The ARAMARK Tower
1101 Market Street
Philadelphia, Pennsylvania 19107-2994

August 2, 2012

On behalf of the Philadelphia Water Department (PWD), I wanted to thank you and your colleagues at the PADEP for taking the time to meet with us on June 14 to discuss your comments submitted June 6, 2012 on our Implementation and Adaptive Management Plan (IAMP) submittal.

David Burke's Comments

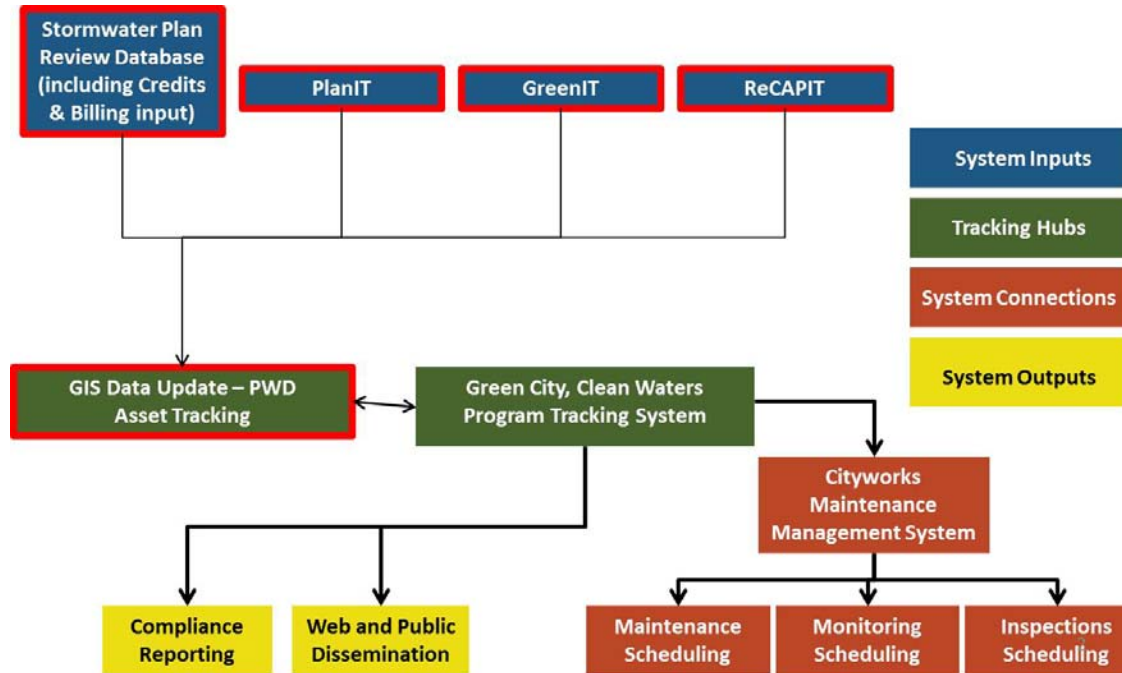
1. **Section 2.1.1 (“Tracking System Development”)** contains a brief discussion of the Interim Tracking System and the Green City Clean Waters Program Tracking System (“GCCW System”). DEP requests that the City provide a more detailed schedule for the completion and implementation of the GCCW System. The language in this section implies that the system may not be completed until the fifth year of the program, and this implied time frame gives DEP some concern. We request Philadelphia Water Department’s (“PWD”) explanation of why this task is extended over such a long time, as well as a discussion of how PWD intends to handle the transition from using the Interim Tracking System to using the GCCW System.

As described in the IAMP, the Water Department already has a number of robust data tracking systems in place and being utilized. What is planned is the integration of these existing data tracking systems through the creation of a *Green City, Clean Waters* Program Tracking System “hub” as a means of simplifying the compilation of information from these various systems for improved information dissemination and regulatory reporting. On page 2-2 of the IAMP, the following figure illustrated PWD’s vision for linking project tracking information.

In the months since the IAMP was submitted, PWD initiated updates to some of these systems to enhance their ability to track data and prepare for the development of the Green City, Clean Waters “hub”. This has resulted in an evolved graphical representation of PWD’s vision for the master

tracking system. Highlighted with a red outline in the graphic below are sub-elements to the tracking process that have seen significant progress in the past few months.
